**KTA-5**

**KLIPPER GUN**

**12**

**AUGUST 2015**

## PARTS ELIMINATED

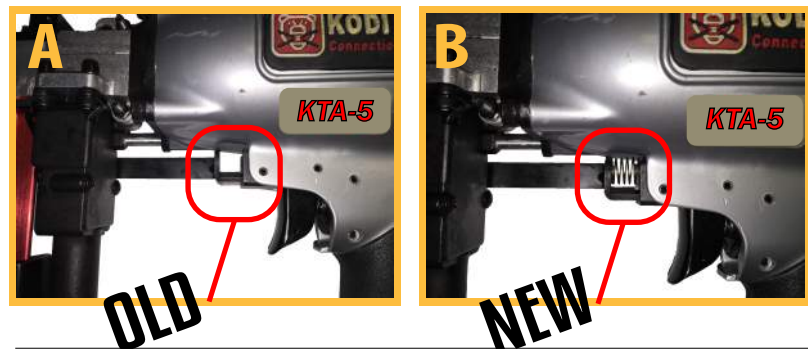
We have streamlined our Klipper Gun by redesigning one side of the Nozzle Assembly. Parts have been eliminated and the Safety Actuator Spring has been moved.

The *new* Nozzle eliminates the need for the following parts:

PART #	ITEM	QTY
70-15422	Safety Cover	1
70-1B140	Spring Pin	1
70-A6607	Bolt	1
70-B6603	Bolt	1
70-10428	Spring	1

Included with this Service Bulletin is an updated parts breakdown and one (1) Safety Spring [PN: 70-10127]. Here is the Field Fix:

1. Install the new Nozzle [PN: 70-35421] as you would the old Nozzle [PN: 70-25421], note that you will no longer need the parts listed in the PARTS ELIMINATED box above.
2. Place the included Safety Spring [PN: 70-10127] between the flat side of the Safety Unit [PN: 70-15408] and the Safety Guide [PN: 70-10407]. [See Figures A & B]
